City of Albuquerque

RE: REVISED DRAINAGE PLAN FOR BOB MYER'S USED CAR LOT
(J-19/D42) REVISION DATE JUNE 8, 1987

SUPPLEMENTAL REPORT

GRADING AND DRAINAGE PLAN AND TOPOGRAPHY SURVEY MAP

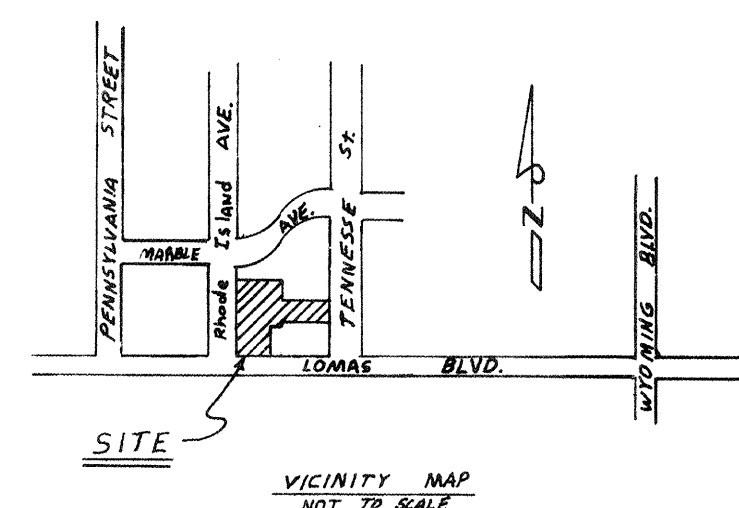
The purpose of this report is to supplement the original drainage investigation furnished to the City Public Works Department Engineering Group in mid-May of this year, by addressing certain other items required by the Hydrology Section in its letter of May 18, 1987, addressed to George E. Paul.

1. Vicinity Map: Refer to two attached copies of the Grading/Drainage (Site) Plan, amended to provide this requirement.
2. Benchmarks: Refer to two attached copies of site plan, also amended to show T.B.M. on site and Control Survey Vertical Datum.
3. Approved filed copy of plat showing referenced lots: Submitted herewith are copies of the recorded plats involving these lots.
4. Cross-Lot Drainage: Attached are conveyance statements from the owners of Lots 13-19, Block 21, East End Addition, granting lot use for common access and drainage.
5. "Notes" Part from Sign off, No. 19 Format: The notes are now incorporated into the Site Plan as requested. (Refer to two amended copies attached).
6. On-Site developed and undeveloped flow volumes: Site is fully paved (bituminous surface course), hence following calculations are for developed flow only:

9. Calculations for capacity of proposed 24" sidewalk culvert:

10. Identify/quantify off site flows, if any: None exist. Refer to Vicinity Map. Abutting streets (Lomas Blvd., Tennessee St., Rhode Island St.,) are fully paved and curbed. Flows are restricted to paved street sections.

11. Direction and location of roof drains: None exist. Sheet flow only, off roofs onto pavement. (used 0.95 coeff. for roofs, instead of min. allowable of 0.90)

13. Encroachment Agreement: Asphalt is not proposed within city right-of-way, hence agreement is not applicable (see Grading/Drainage Plan).

14. Cross-section of proposed sidewalk culvert: Refer again to City Standard Drawing No. 2236, with Sec. "A-A" looking east. Spot elevations at flow line of gutter (east end of culvert) and east edge of sidewalk (east end of culvert)

$$Q = \underline{5.023 \text{ cfs capy.}} (\leq 8.048, *) \text{ hence}$$

Use Two - 24" sidewalk culverts

The items requested by Mr. Montoya of the Hydrology Section have now been provided; either by this report or on the amended two copies of the site plan and approval to proceed with erection of buildings as shown, is respectfully requested.

NOTE: BUILD TWO(2) DOUBLE GULVERTS (24" dia) 75" (6'-3") OUT-TO-OUT, FROM BACK-OF-CURB TO BACK-OF-SIDEWALK.
